City of Albuquerque

RE: RIO GRANDE ALBUQUERQUE (J-9/D1B3)
RECEIVED NOVEMBER 5, 1991

I have reviewed the conceptual grading plan dated October 23, 1991 and approve subject to the following:

IO GRANDE OF ALBUQUERQUE CONCEPTUAL GRADING AND DRAINAGE PLAN

TRACTS J & K-1 OF THE ATRISCO BUSINESS PARK
TRACT J = 49.53 ACRES
TRACT K-1 = 4.43 ACRES

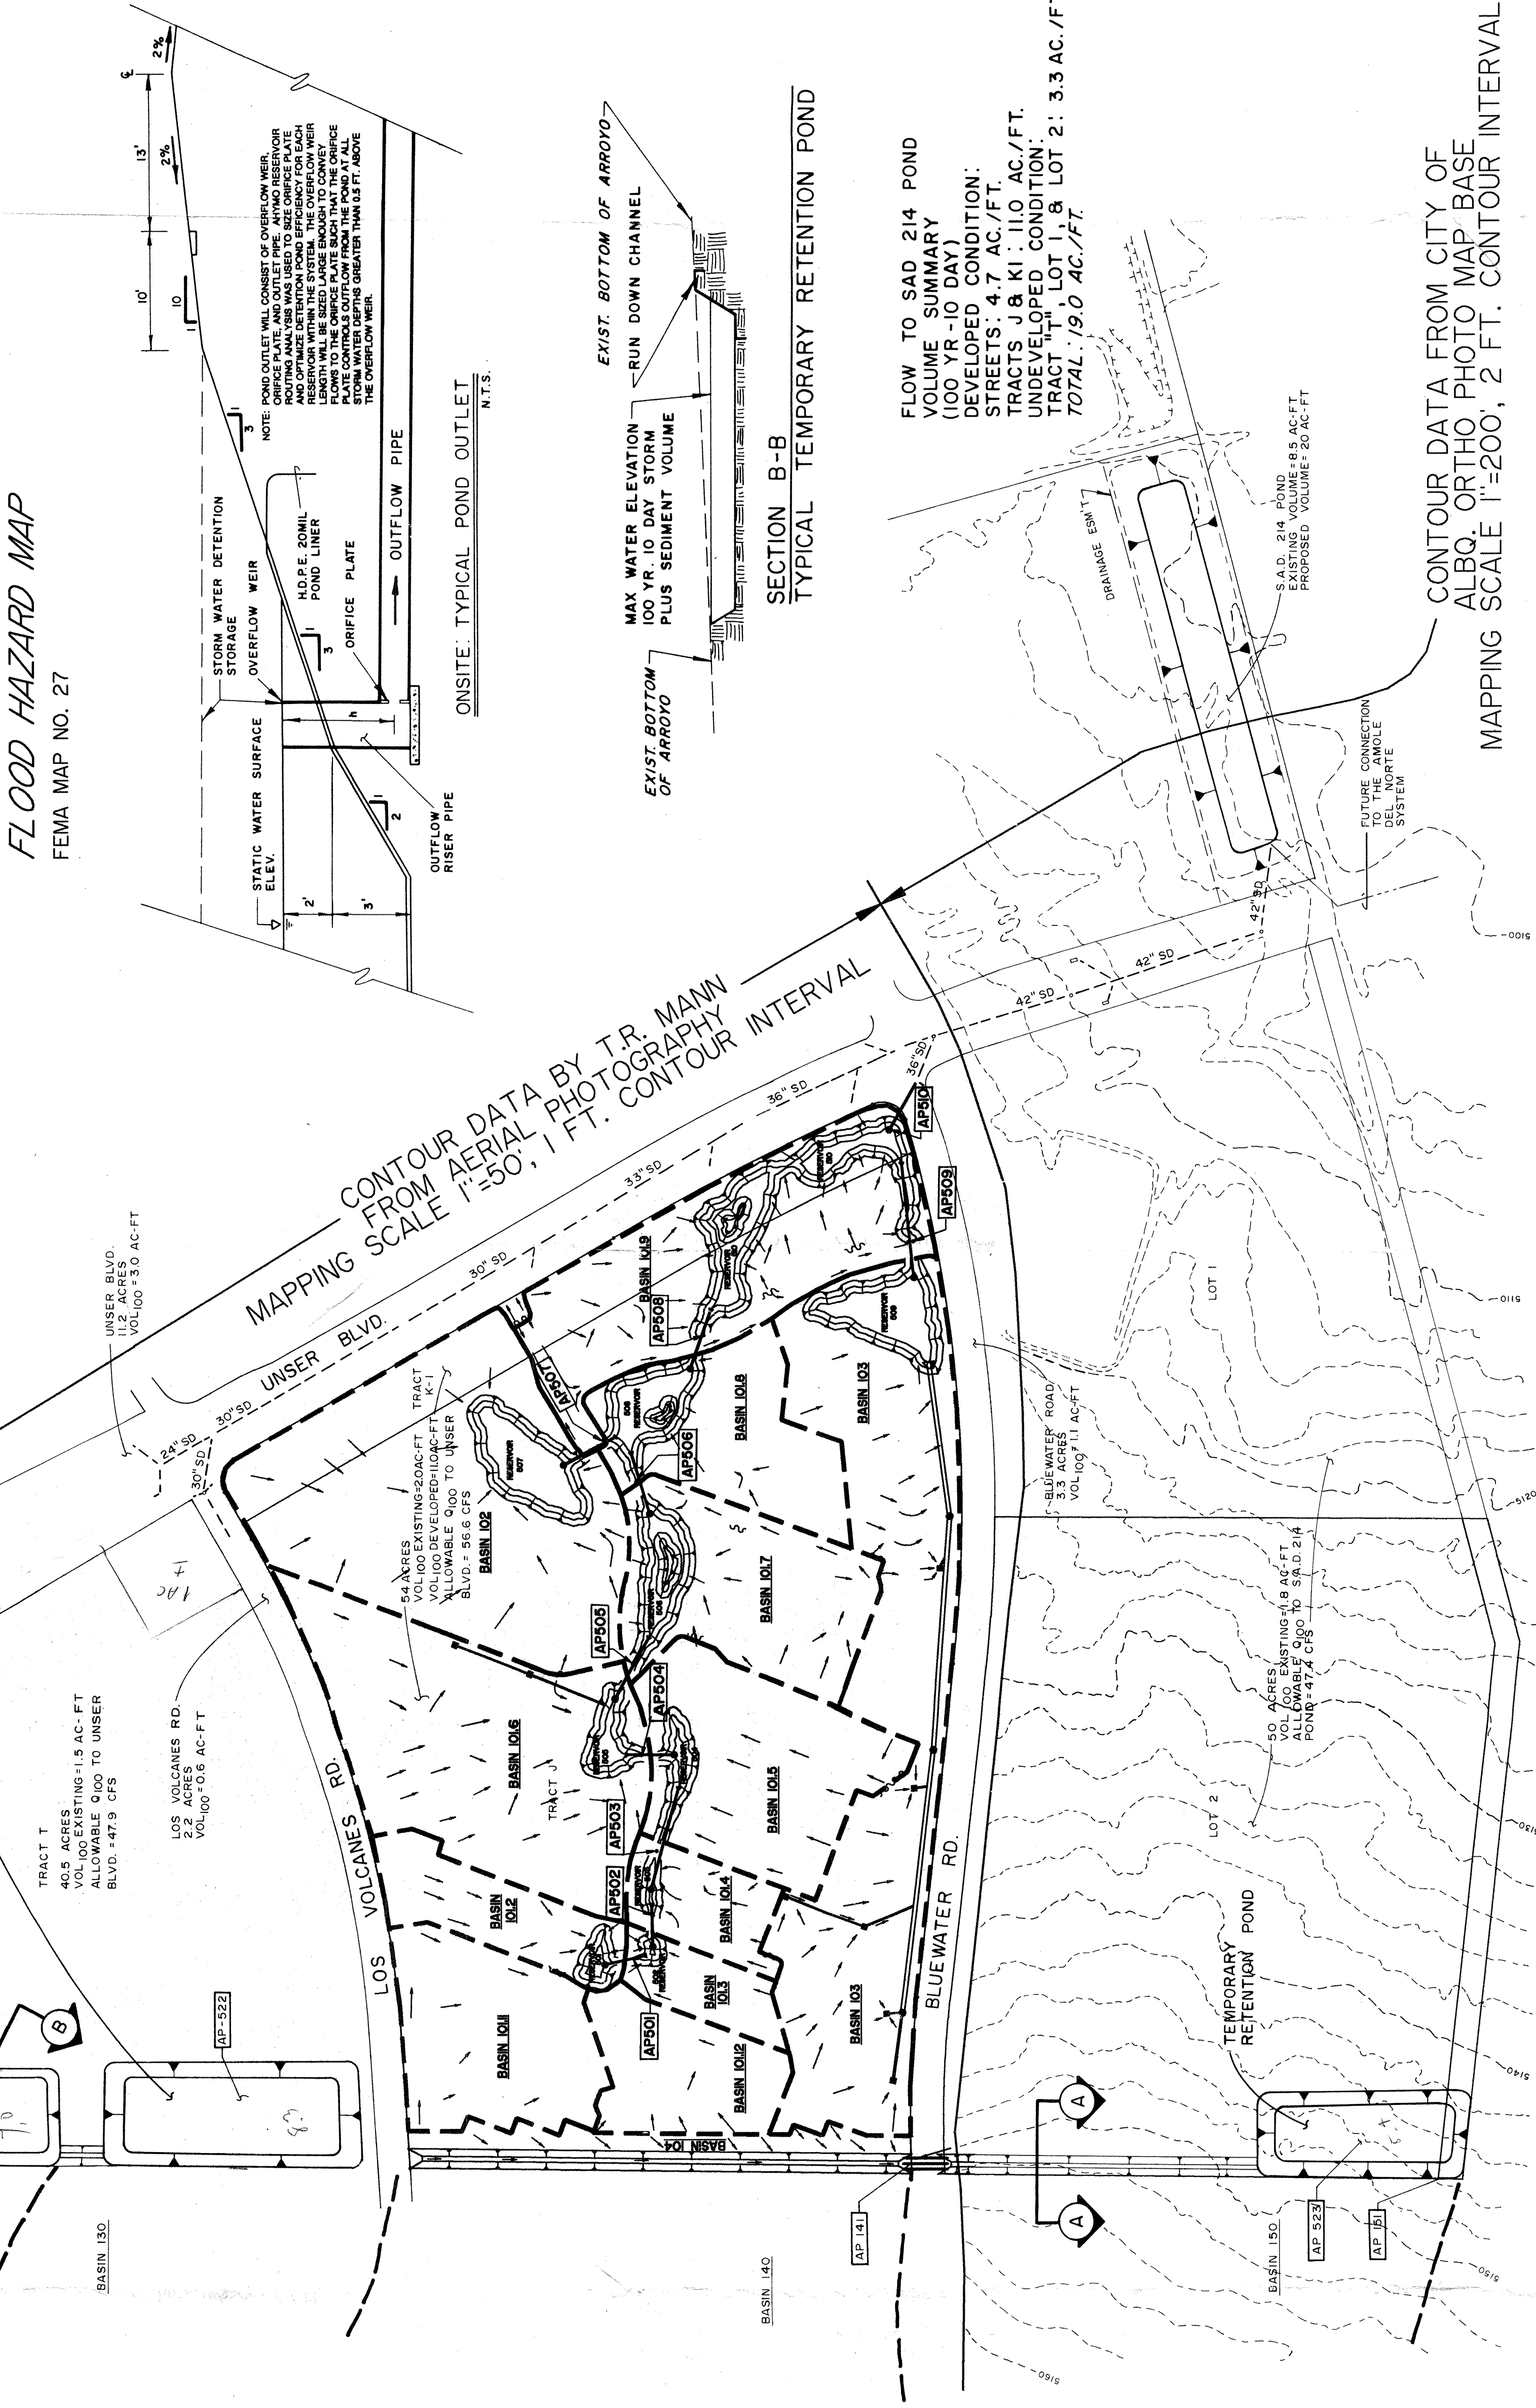
- Concurrence from the adjacent property owners on the expansion and use of S.A.D. pond for the purpose of accommodating Tracts J and K developed storm water.
- Construction of all the retention ponds and berms identified on the subject plan with the first phase of development.
- Acceptance, by the owner(s), of maintenance responsibilities and legal liabilities of the temporary ponds and berms until such time that the permanent improvements are constructed.
- Review by the State Engineer's Office for any state requirements.
- Pursue a map revision for the existing flood plain impacting Tracts J and K.
